ENGINEERING CHANGE NOTICE NO.

04274

DWG NO. 646.3500

DWG TITLE: STRUT

ENGINEERING CHANGE NOTIC. NO. 02440

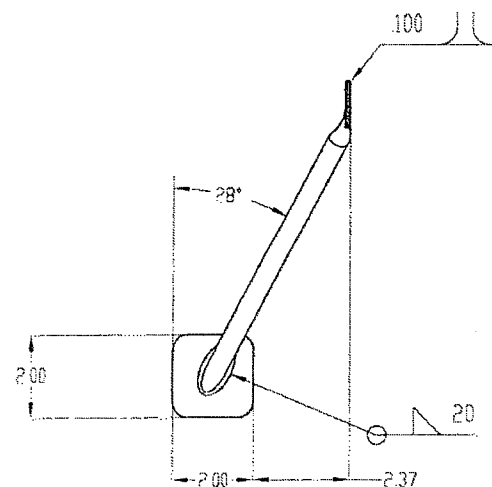
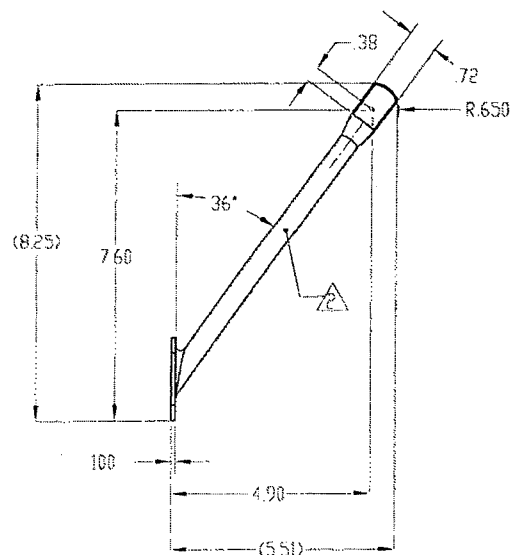
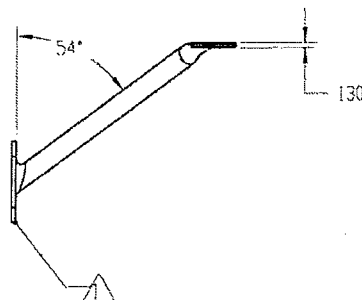
REASON: REVISED GEOMETRY TO ACCOMMODATE NEW EXISTING AIRCRAFT PROVISIONS

SHEET 2 IS:

ENGINEERING CHANGE NOTICE NO.

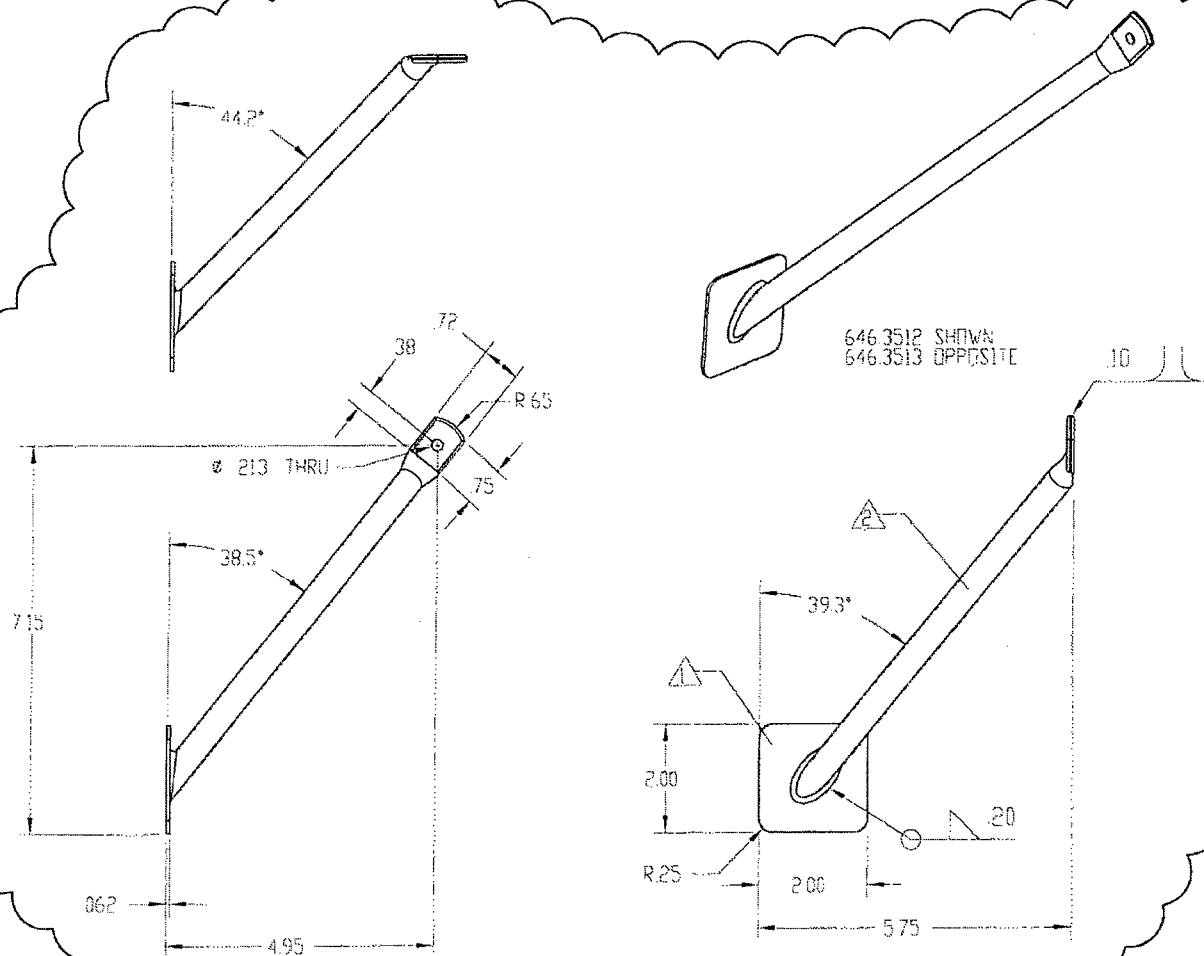
REASON: REVISED ANGLE OF 646.3512 & 646.3513 FOR BETTER FITMENT

SHEET 2, IS:
